Reference: Beaver Valley Power Station, Unit No. 1
Docket No. 50-334, License No. DPR-66
Additional Information - TAC Item 65106
(1) Letter from J. D. Sieber, DLC to USNRC, dated April 13, 1987
(2) Letter from J. D. Sieber, DLC to USNRC, dated December 2, 1987

This letter provides our response to your request for additional information (Telecopy dated January 5, 1988) regarding our request for Technical Specification Change No. 136. The item identified in your telecopied request is reiterated here followed by our response:

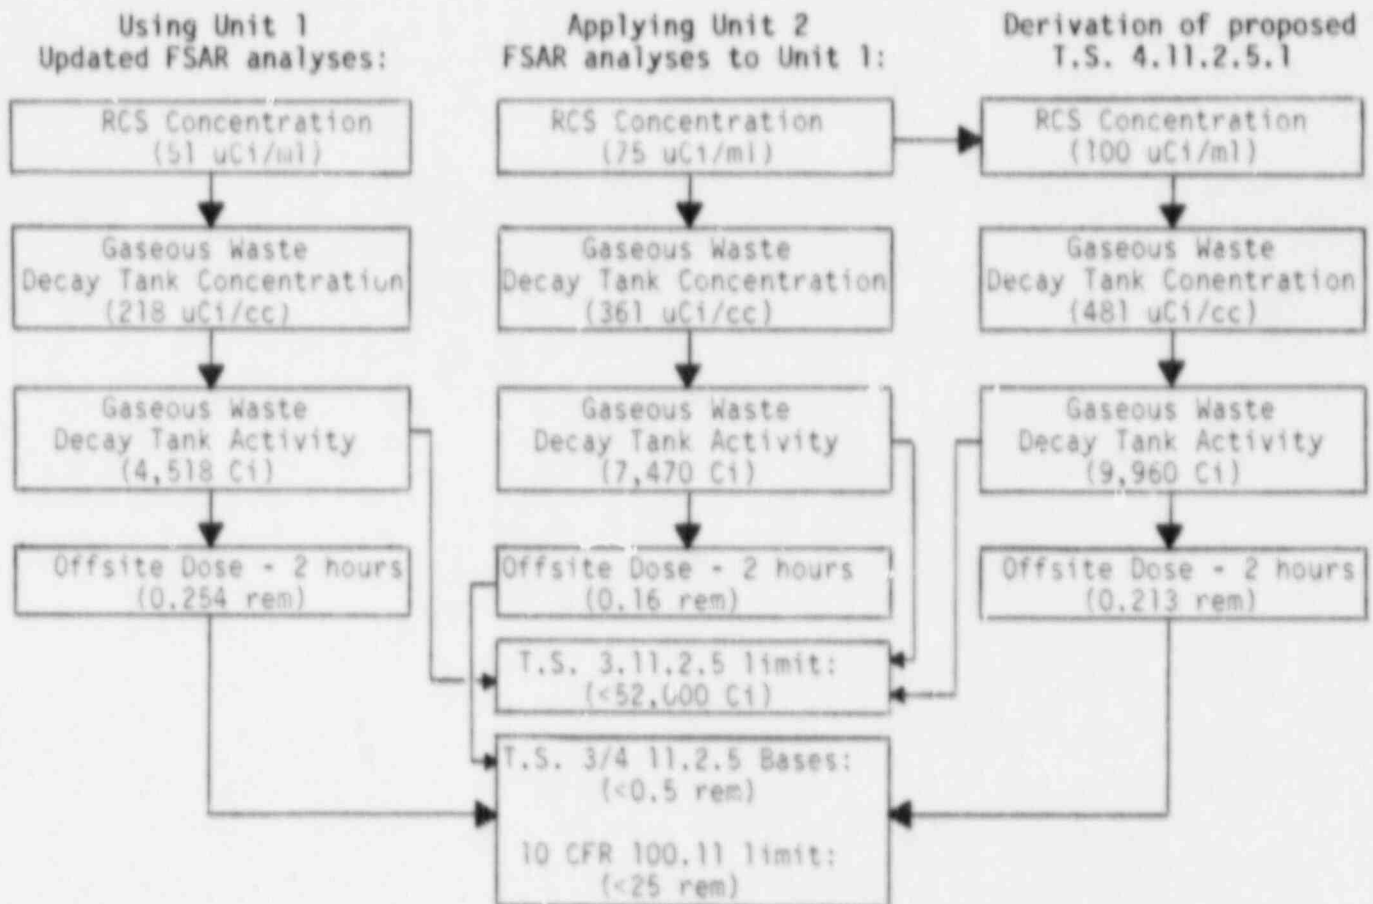
In Ref. 2 (Item 4(c)), Duquesne Light provided information regarding the basis for the value of 100 microcuries/ml. However, Ref. 2 did not explain the link between the estimated concentrations of gases in the WGDTs (i.e., 361 microcuries/cc for Beaver Valley Unit-1) and the gross concentration in the primary coolant. Provide an analysis that shows that when the gross concentration of radionuclides in the primary coolant is less than or equal to 100 microcuries/ml, then

- (a) The quantities of radioactive gases in each tank is less than or equal to 52,000 Ci of noble gases (i.e., TS 3.11.2.5); and
- (b) In the event of an uncontrolled release of the tanks' contents, the resulting total body exposure to an individual located at the nearest exclusion boundary for two hours immediately following the onset of the release will not exceed 0.5 rem (see Bases 3/4.11.2.5, page B 3/4 11-5).

The following table shows a numerical flowpath (from RCS concentration to offsite dose) when an accidental release of a gaseous waste decay tank occurs at Unit 1.

In summary, DLC derived the 100 uCi/ml RCS concentration (as proposed in T.S. 4.11.2.5.1) by applying the Unit 2 FSAR analyses to Unit 1. This was done because the Unit 2 FSAR yields more restrictive values (ie; RCS concentration, gaseous waste decay tank concentration and gaseous waste decay tank activity) than the Unit 1 Updated FSAR. The Unit 2 FSAR does yield a lower relative offsite dose than the Unit 1 Updated FSAR, but that is due to more recent conditions (eg; computer codes, dispersion parameters and deposition parameters).
